# Comments on SPP 2015 Reserve Margin LOLE Report

### Reserve Margin Loss of Load Expectation Study Results

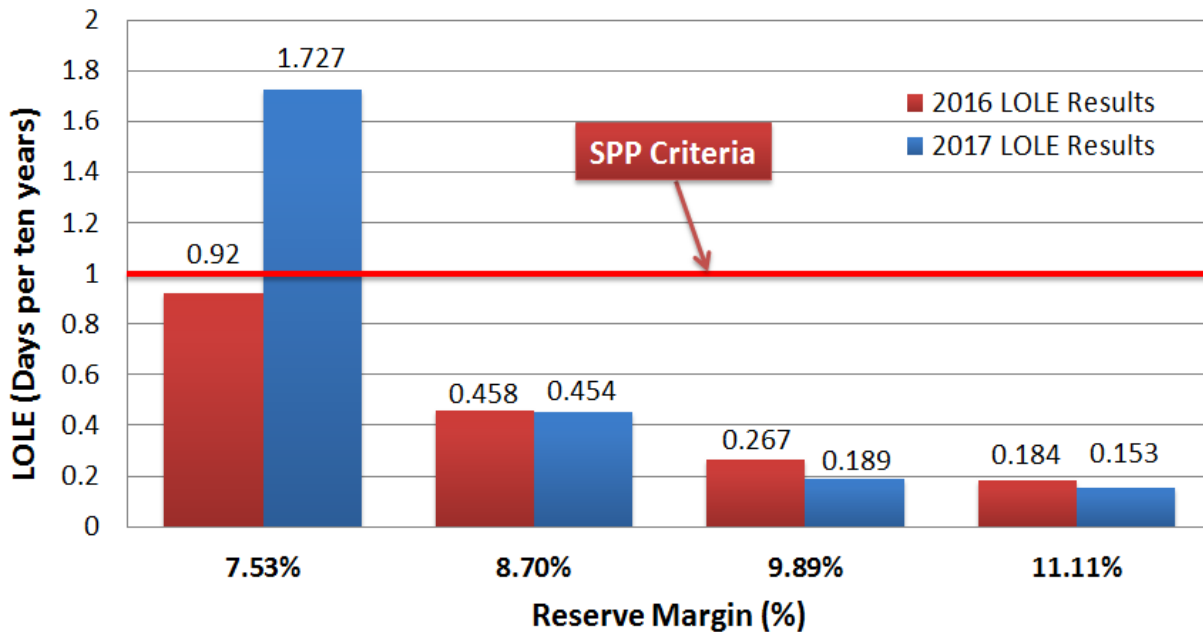
- SPP’s lower reserve margin to meet the 1 in 10 LOLE criterion (compared to PJM’s) appears to be driven by the following two factors:
  - Load Forecast Uncertainty
